LAND

The Land section describes the characteristics of the proposed development site land, their limitations for the proposal and likely impacts.

Detailed land characteristics and environmental constraints of the proposed development site

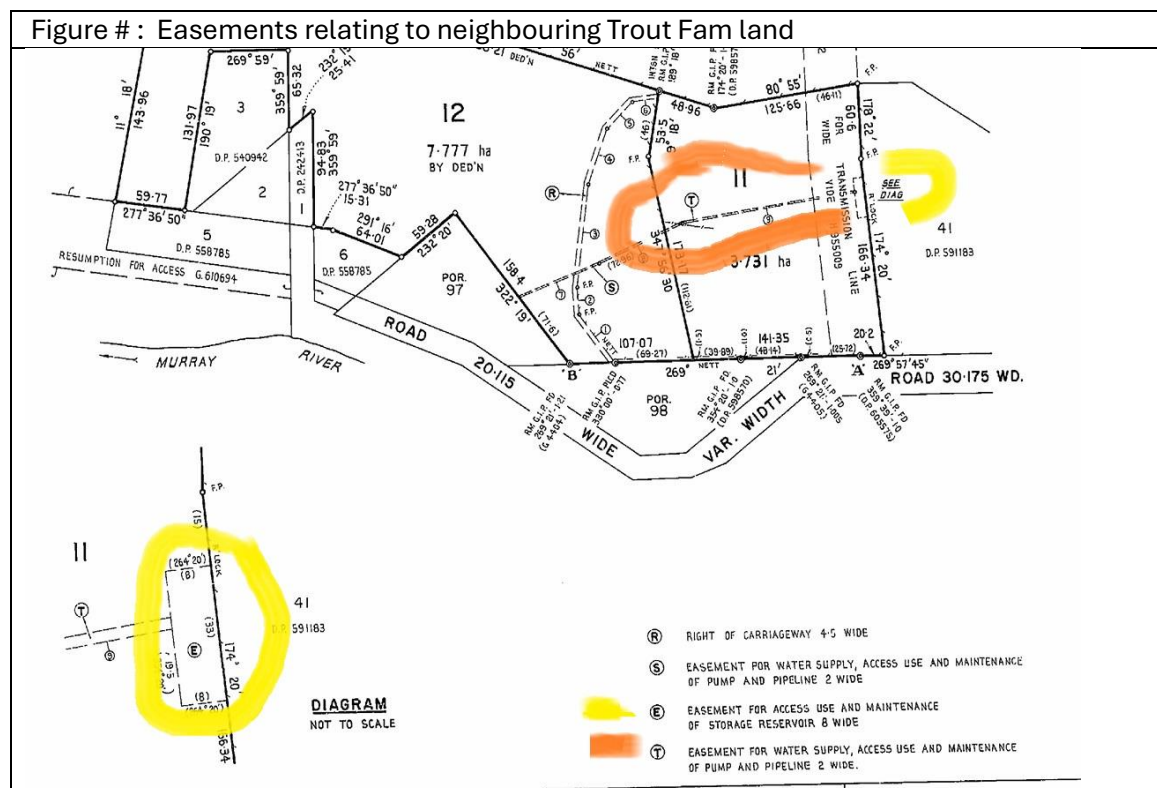
Not listed in the EIS are the associated reciprocal entitlements the Trout Farm land has over water supply access easements located on the proposed development site land (Figure : Easements relating to neighbouring Trout Fam land). The areas marked orange and yellow identify the location of the easements relating to the neighbouring Trout Fam land.

An adjacent neighbour has the right to the easement, and it must retain access. BESS structures can not be located over it. The water related easements are not mentioned in Section 1.6 Restrictions or covenants, p 5) but critically relevant as it may be “subject of a separate approvals process” (SEARs general Requirements. P 1)”.

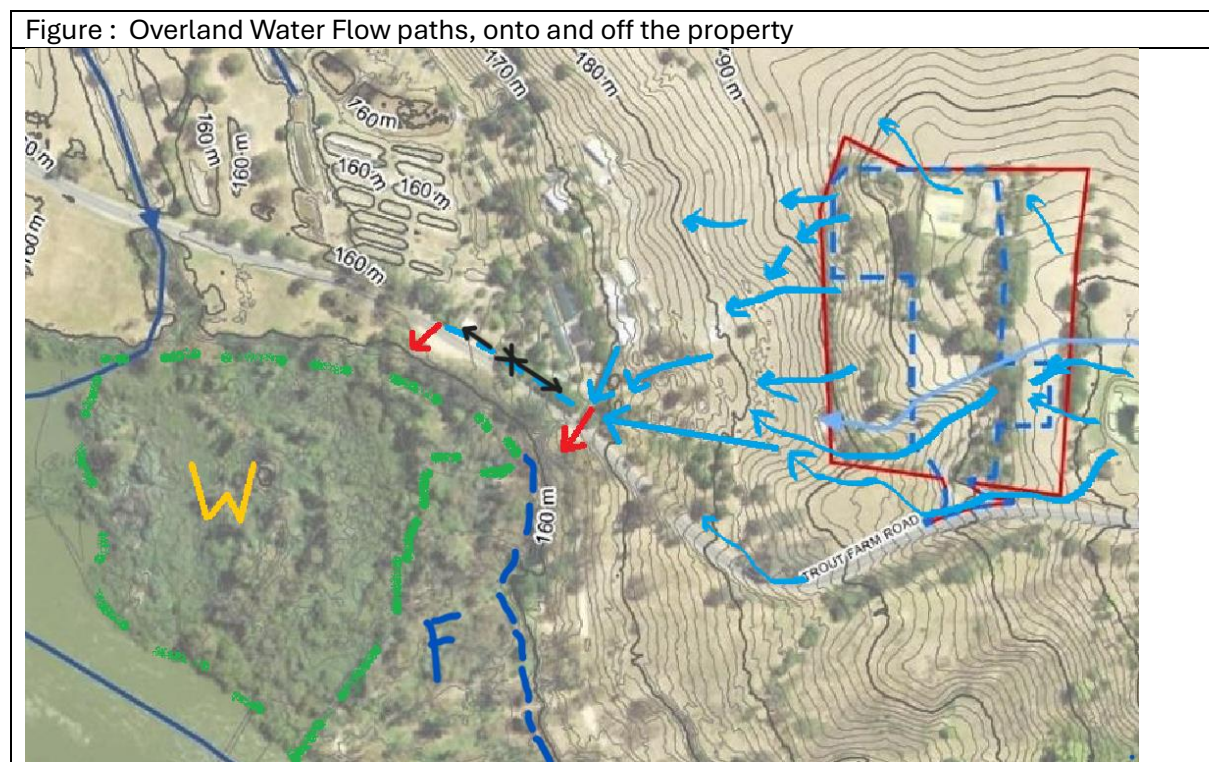
The EIS provides a map of “Waterways and overland flow paths” for the property. That map interpretation shows a single flowline and obviously a desktop interpretation as the in the entire flowline of the property is positions approximately north on the map half way up a steep drop off (see Fig 7-17, p 142).

It is far short of the detail assessment required for site runoff, and run-on, for proposed project where almost all of the site is either concreted or hard paved. A more appropriate detailed map is provided in Figure : Overland Water Flow paths, onto and off the property, below.

- Flow path determination is too coarse and does not adequately consider:
 - run-on from land above, or
 - the end point of runoff onto the Trout Farm land; and the wetland/Murray River known to have occurred.
 - site runoff, for proposed project where almost the whole site is either concreted or hard paved

Figure : Lanark - Shallow Soils and “Rock”

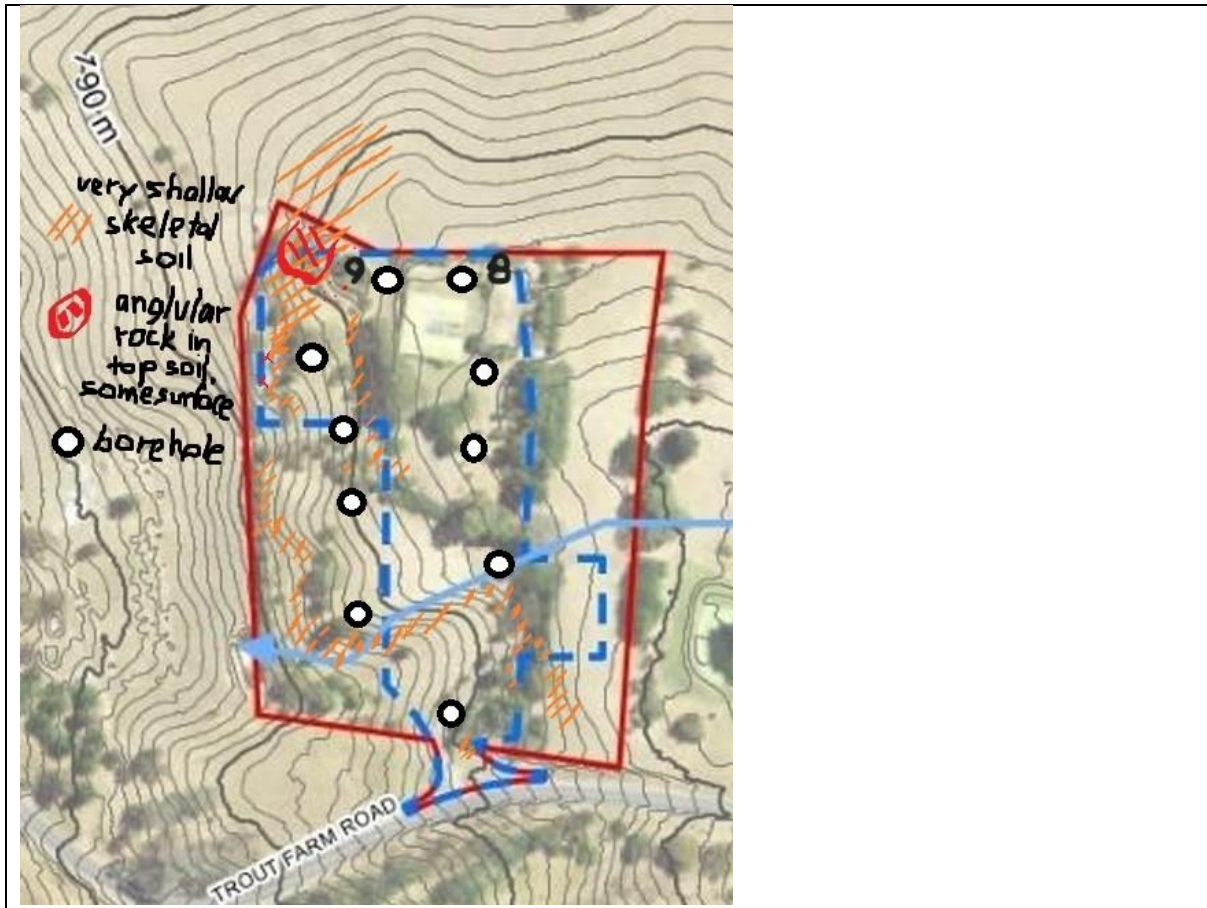
The EIS states “no rock is present” :

- “there are no rocks present” (Appendix E, Section 7.2.1, no page numbers) and
- “No rocky habitat on site” (Appendix E Table 2-4 (no page numbers) **relating to “Habitat Suitability: Pink-tailed Legless Lizard: Rocky areas or 50 m of rocky area” listing the candidate species being Pink-tailed Legless Lizard, a threatened species”.**

There are rock/stone areas on the property as identified with a red circle in Fig : Shallow soils and rock, above

Figure #a: Steeper shallow soil areas

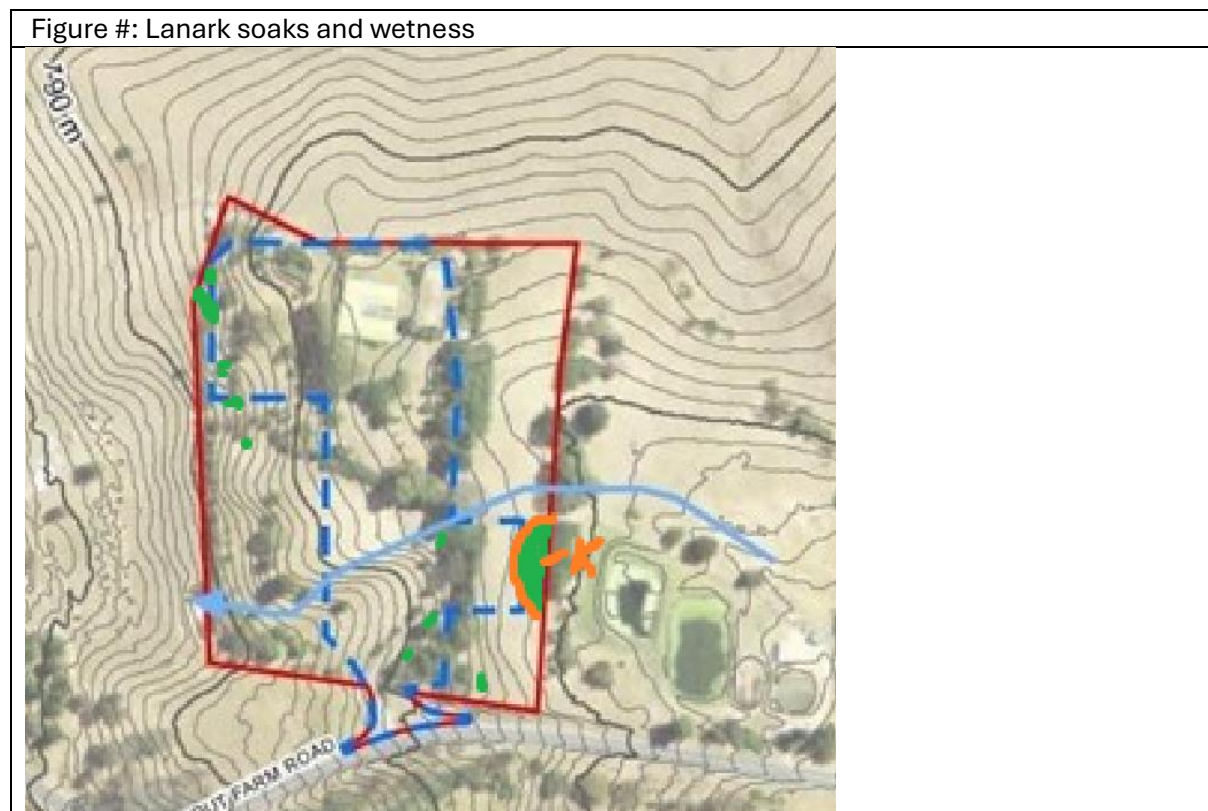
- a change of slope below the steeper shallow soil areas (see Figure : Lanark soaks and wetness ,overleaf), Subsurface seepage is visible in the uphill side of the entrance road cutting after soaking rains and the soak adjacent the Trout Farm Road is to be avoided with vehicles as a fencing contractor learnt the hard way after driving there.
- shallow rock band

Figure #b: Soaks and wetness

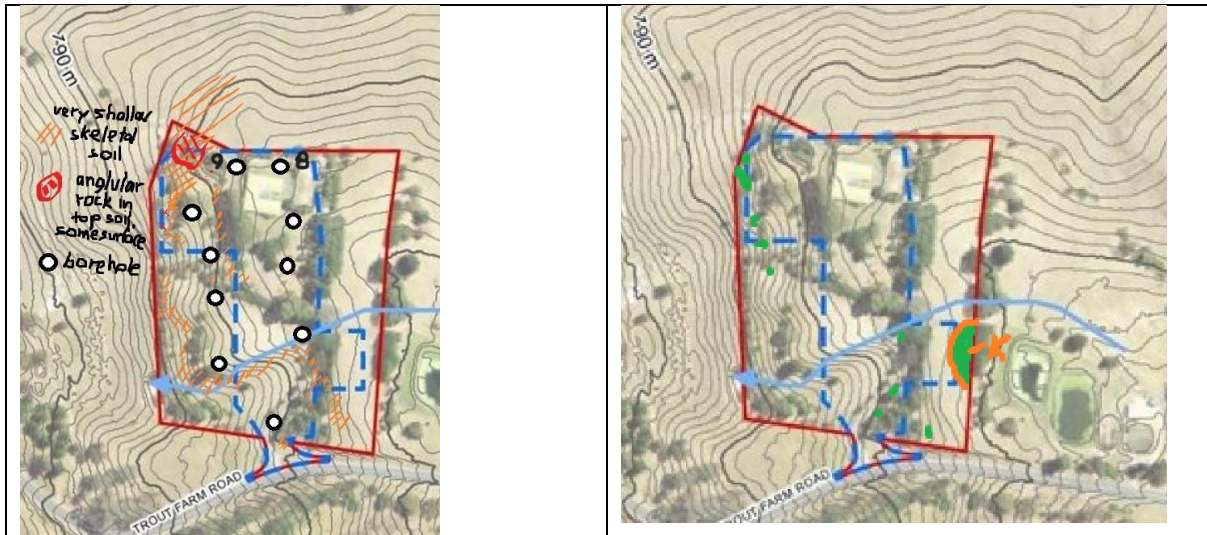
Soaks occur at several locations on Lanark most years and addition areas appear in particularly wet years. These have been identified on Figure # below. The annually wet areas had wet indicator plant species such as rushes, paspalum grass and are untrafficable by foot or 4WD

The portion of Lanark immediately below the sewerage treatment ponds is quite wet and boggy for a portion of most winters. The extent reflected by an area of Kikuyu Grass (marked “K” on Figure # Soaks and wetness) and stays green well into Summer; and required gumboots to be worn in winter.

- **ACHAR consultants need to be advised of the presence of these soaks and assessed SAL status if they are significant as the soak identified on Crown Land Lot 98.**
- **Proponent of the development needs to be aware of this land characteristic risk and the effect it will have on the cut/fill presently designed**
